QUESTIONS + ANSWERS

5/30/23

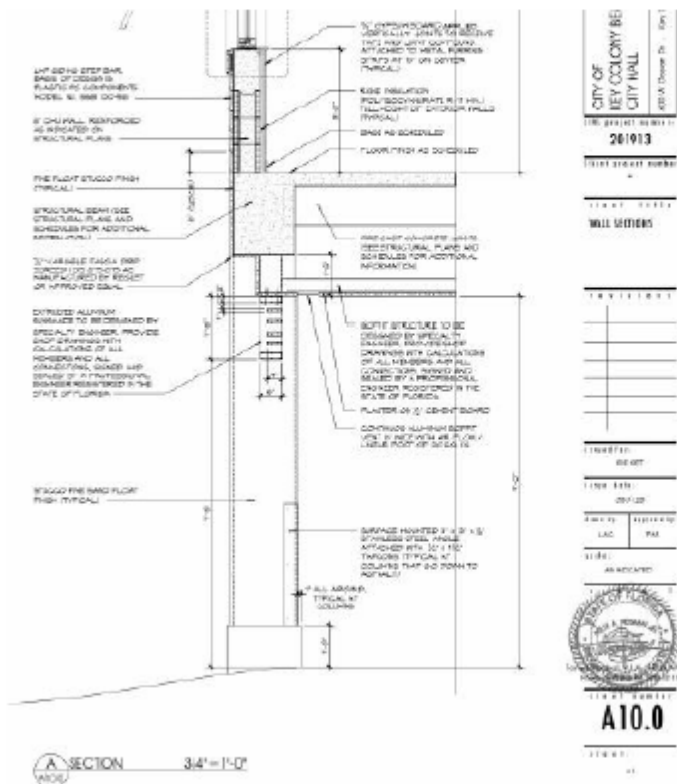
Please clarify if the cement fiber board is to be wood grain finish or smooth finish. Please verify if the size is 6 ¼" or 7 ¼".

If you are referring to the exterior Allura soffit panel then, like the note states, on Detail 1/A4.1 it shall be a traditional Cedar texture. Use the size 7 ¼".

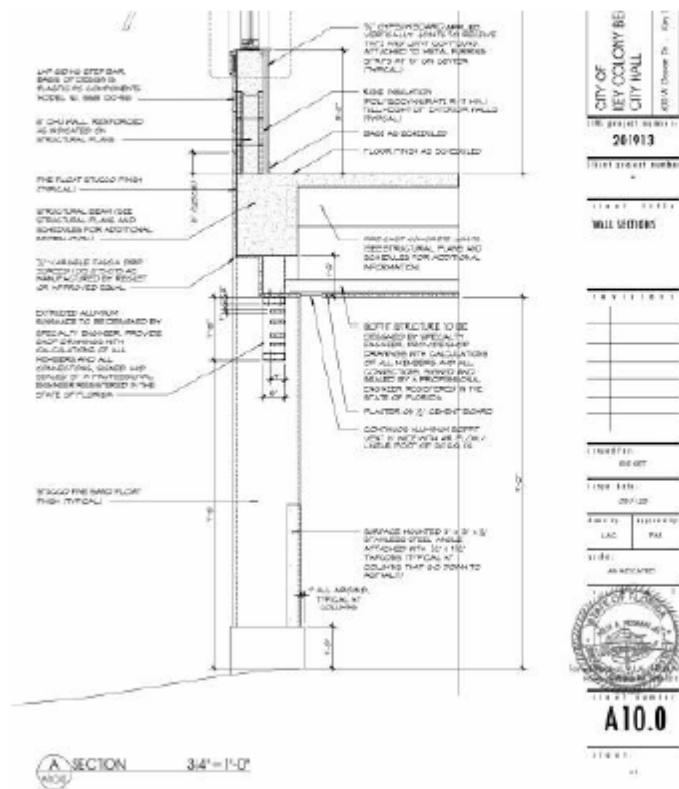
Please clarify if the sunshade system should be steel or aluminum, page A8.2 calls for both types. Please advise which is correct.

The sunshade shown in the section below is called out to be extruded aluminum. Finish shall be Kynar 500

Sunshade shown in section B/A10.0 shall remain as steel.

r e v i s i o n s	
△	RFI CLARIFICATION

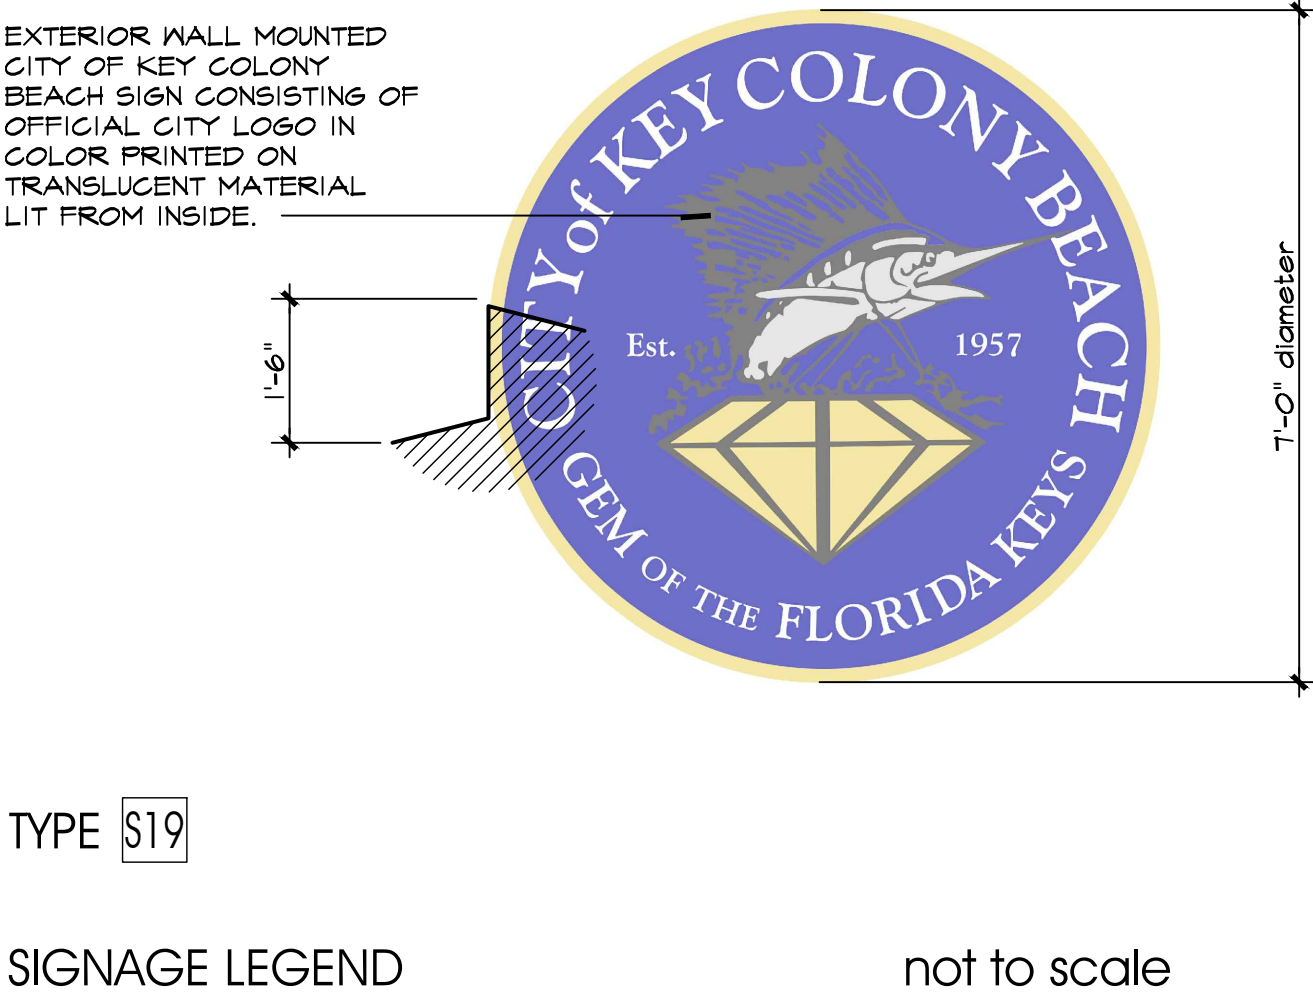
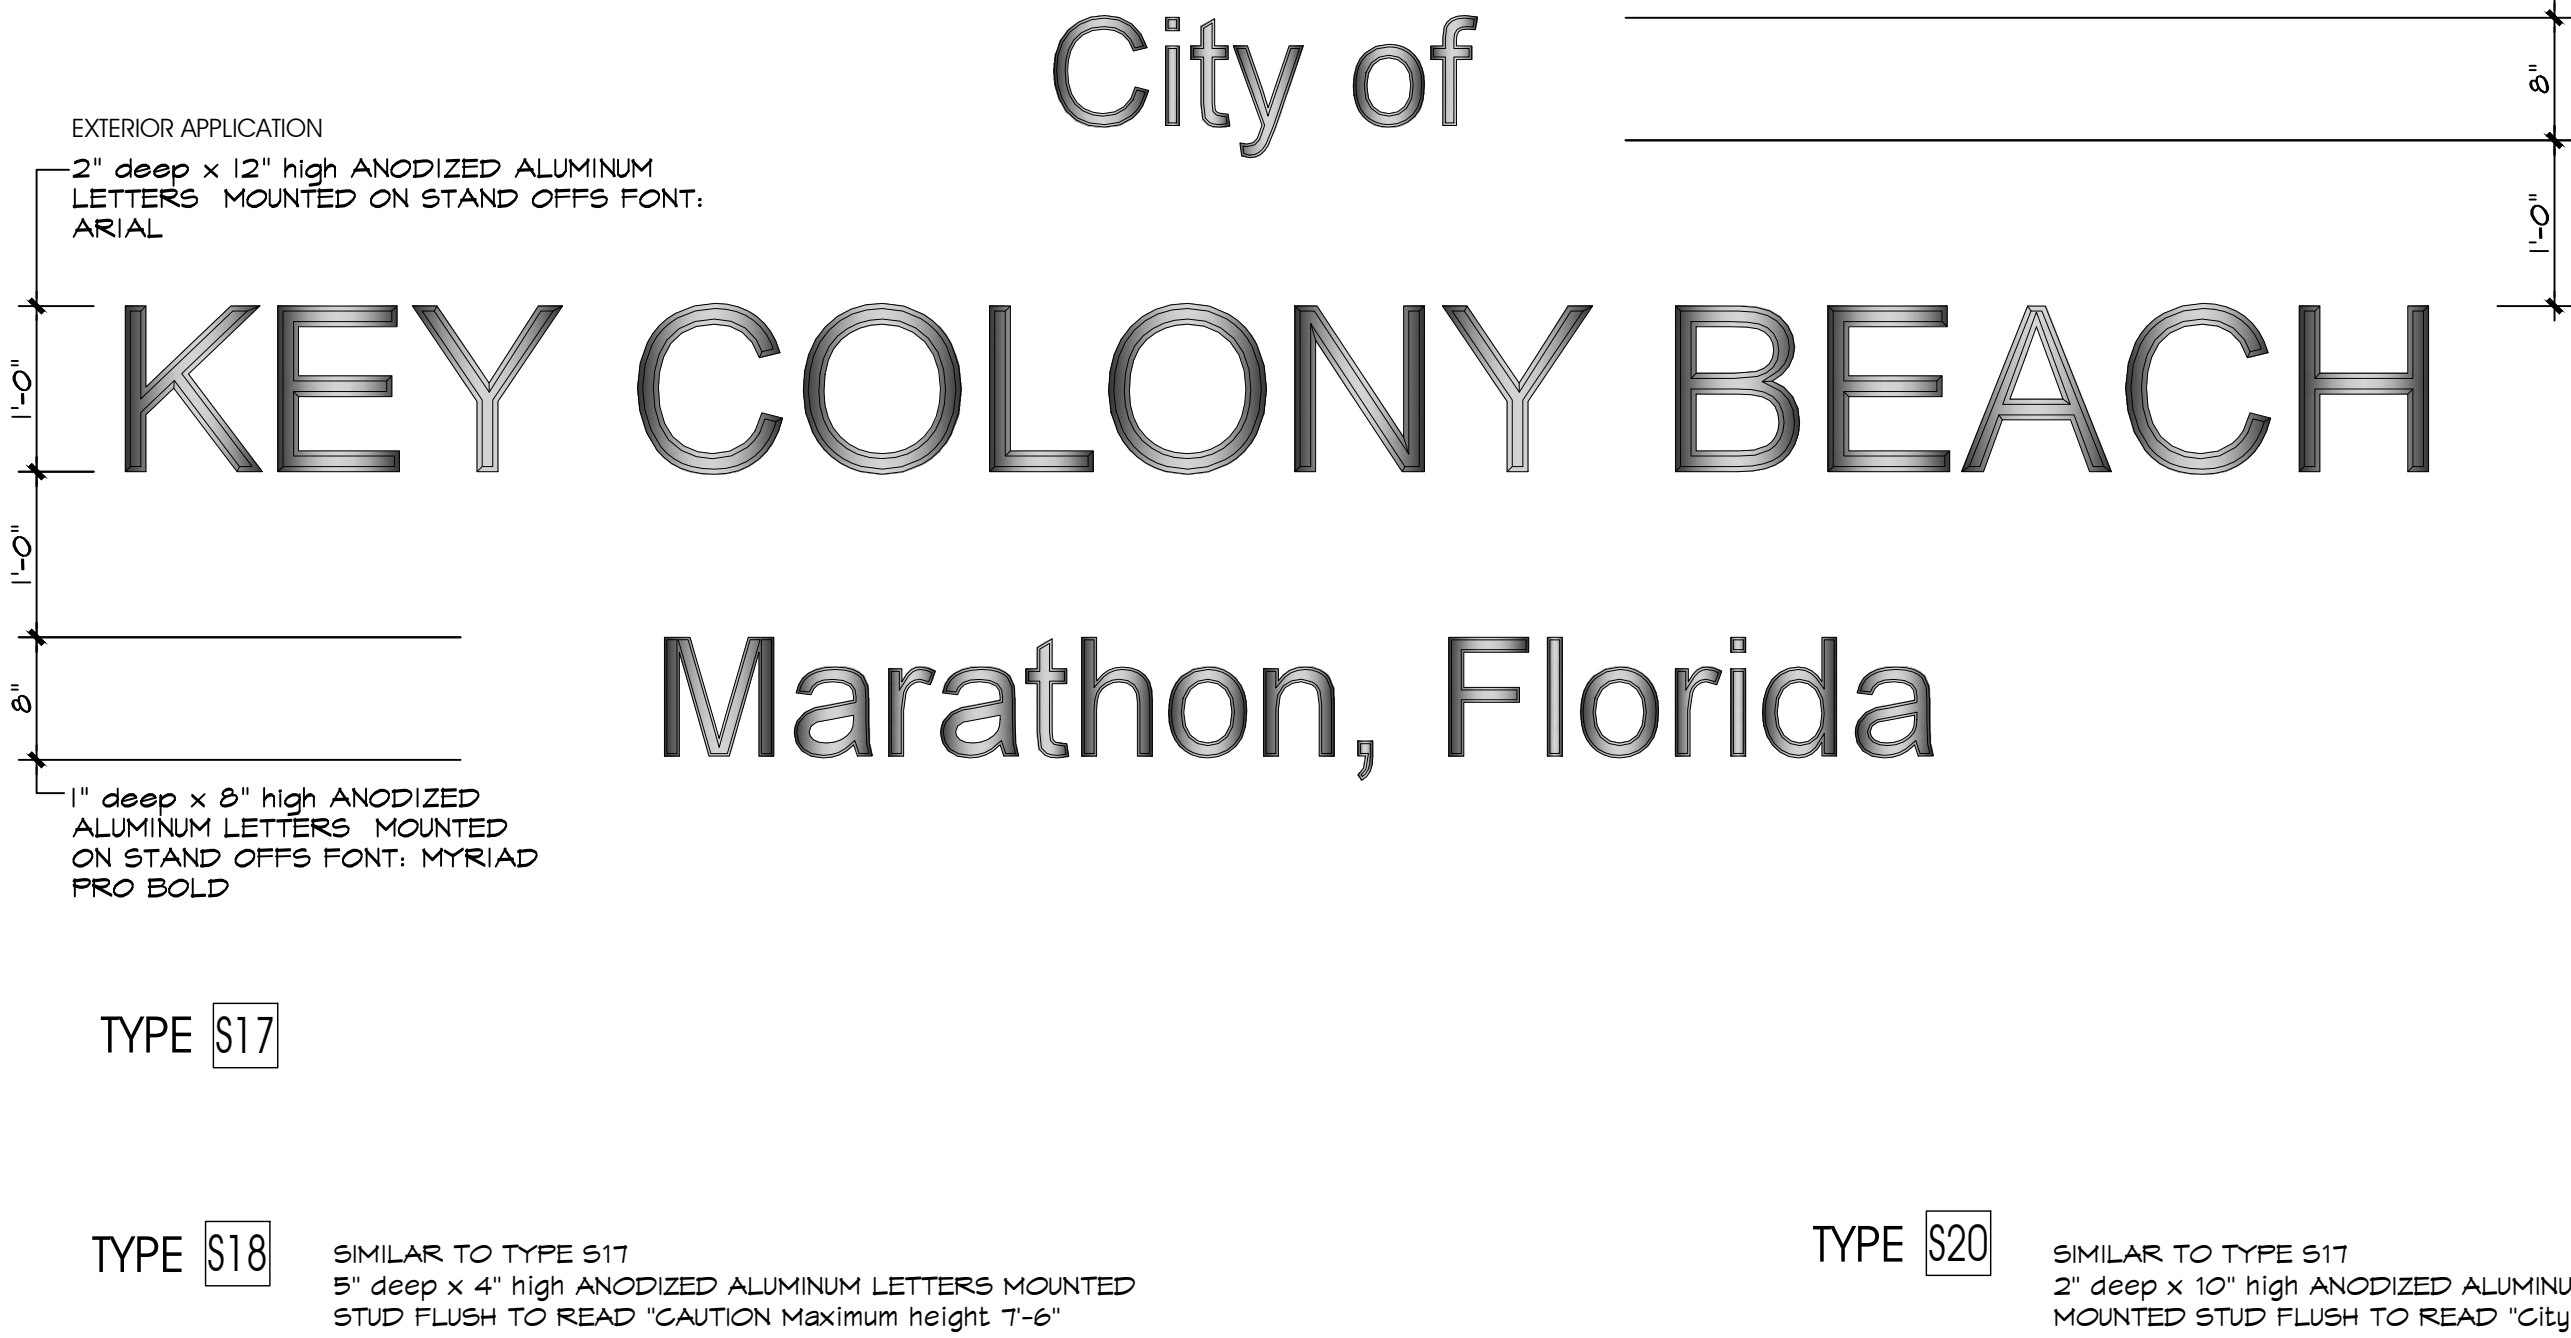
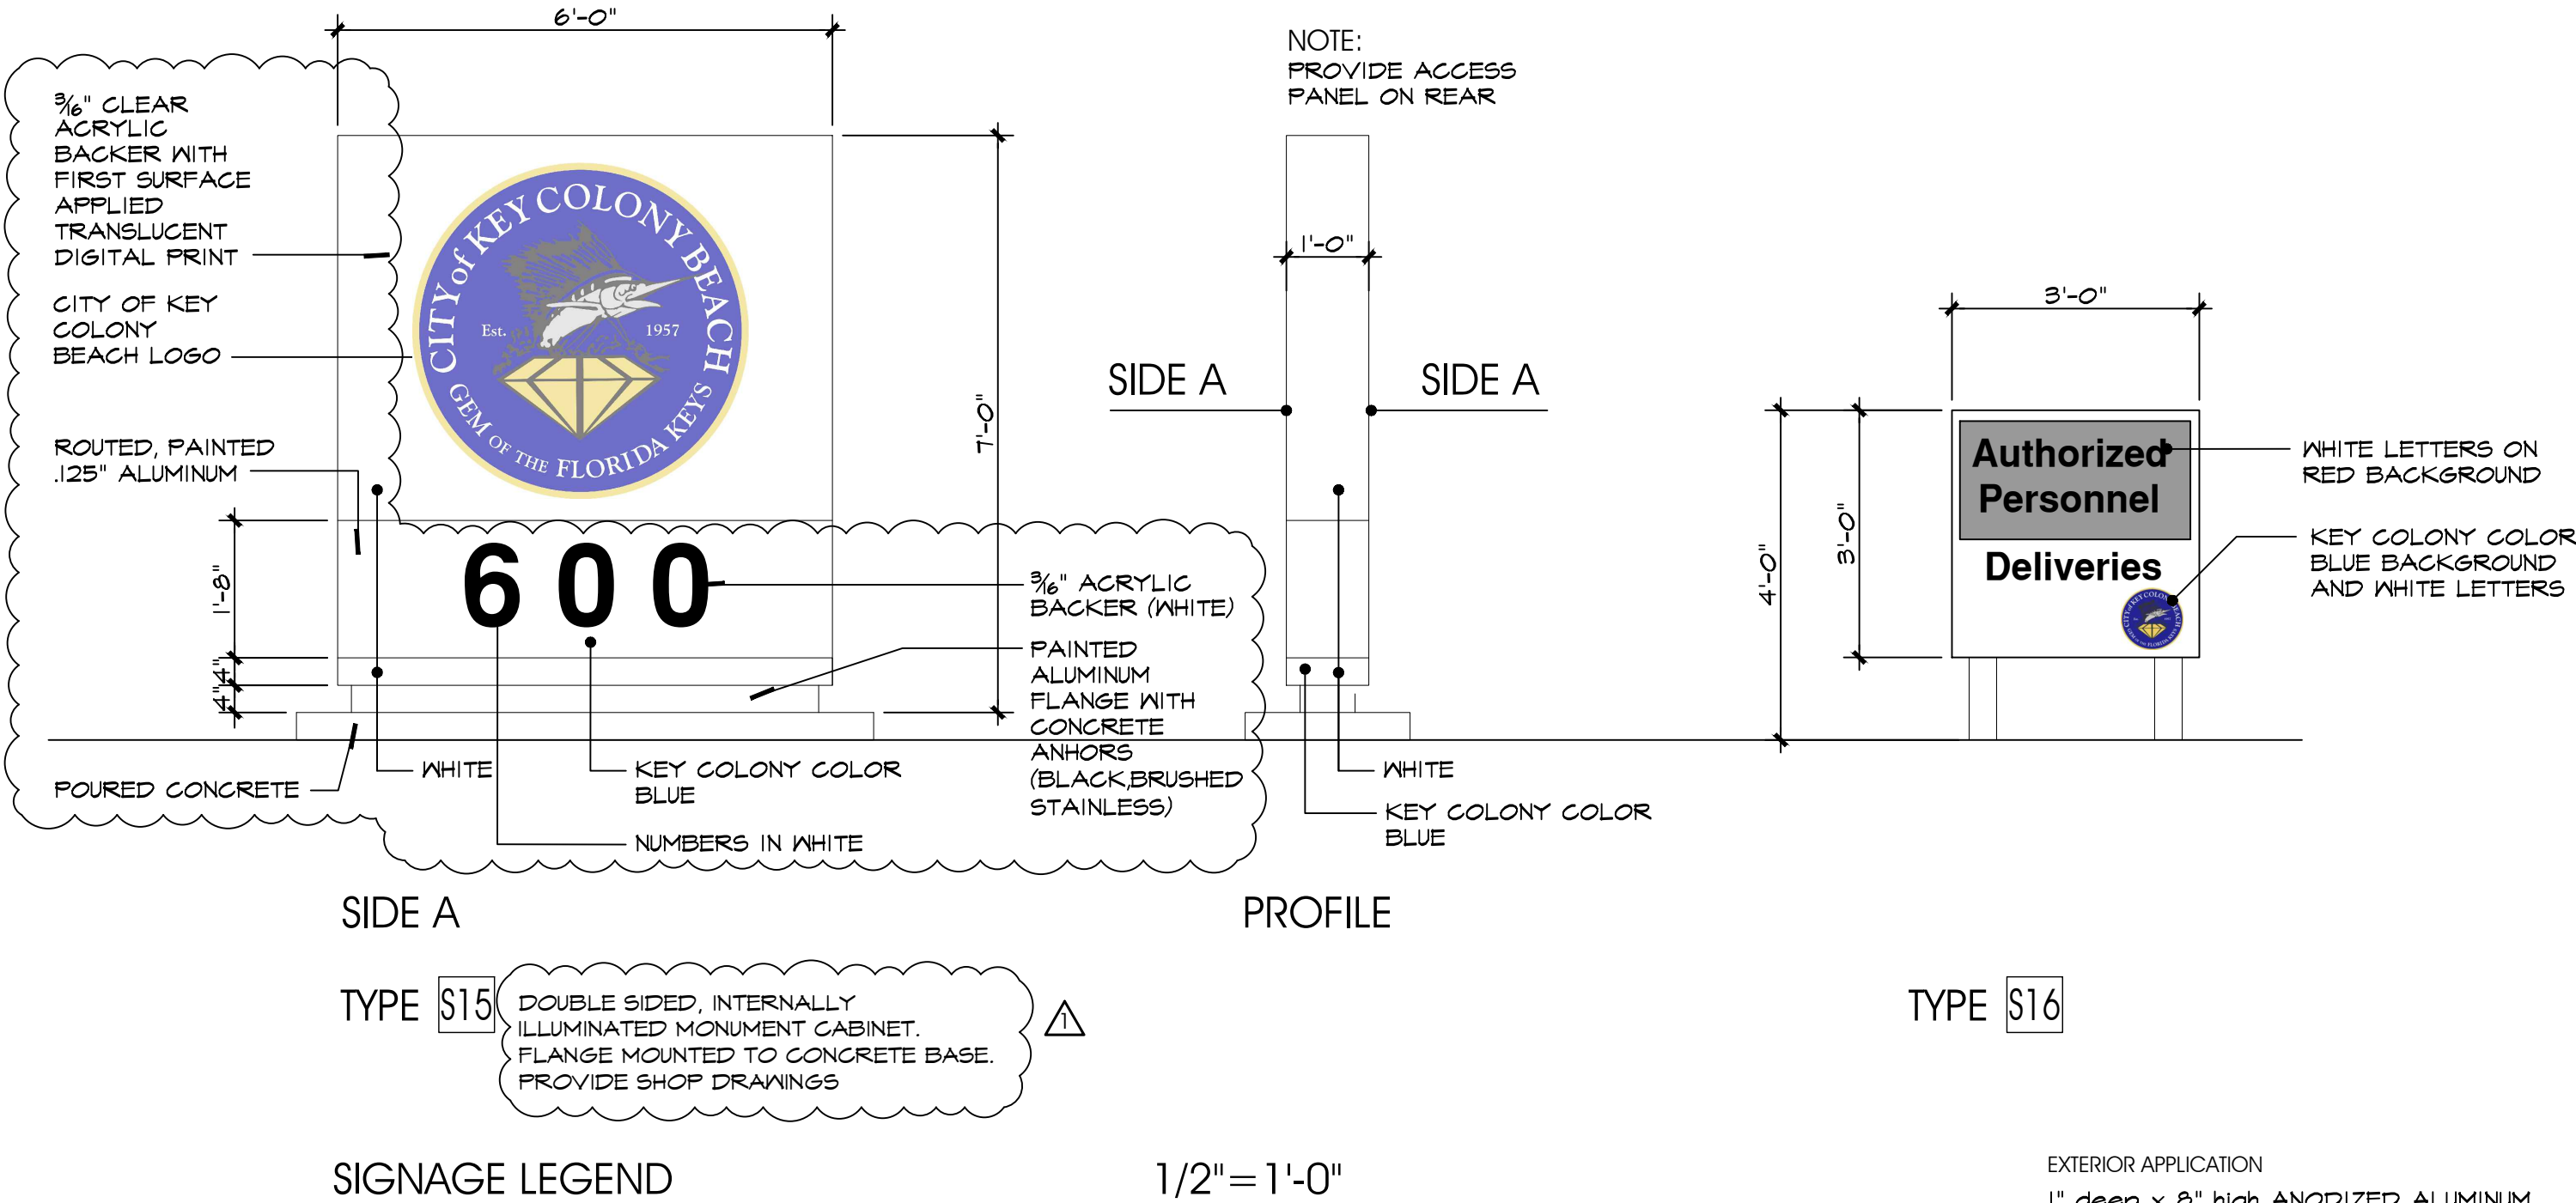
Please clarify the sign material for the exterior city logo. Is the material aluminum? Is the sign going to be backlit or have a light shining on the exterior city logo?

See attached revised sheet A16.1 with additional information.
